No. 90-16

Timing and Maximum RPM Changes

MCM 502 Magnum Stern Drive Engines

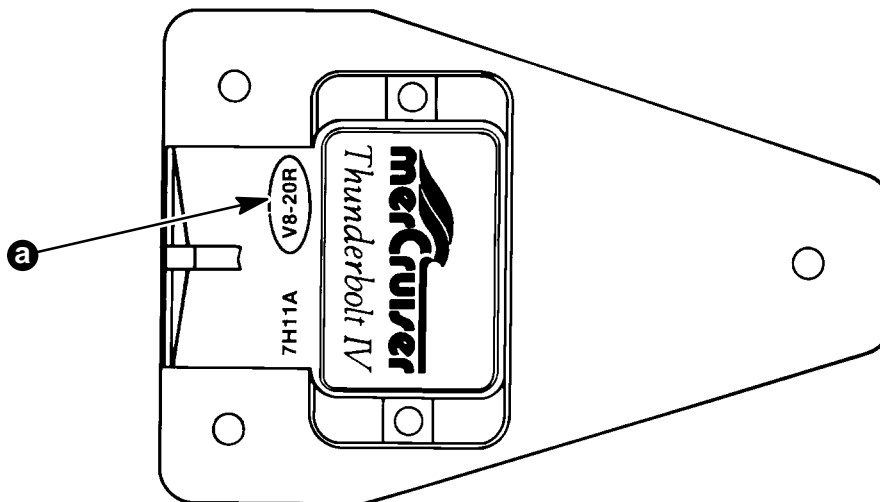
Engines built below the serial number shown may have the wrong ignition amplifier installed on them, incorrect timing and as a result be propped at the wrong maximum RPM.

Look at amplifier to see if it is the correct one.

Correct amplifier will have V8-20R at (a). Incorrect will have V8-22B.

Retime engine to 8° BTDC. Reprop engine to run between 4600-5000 RPM.
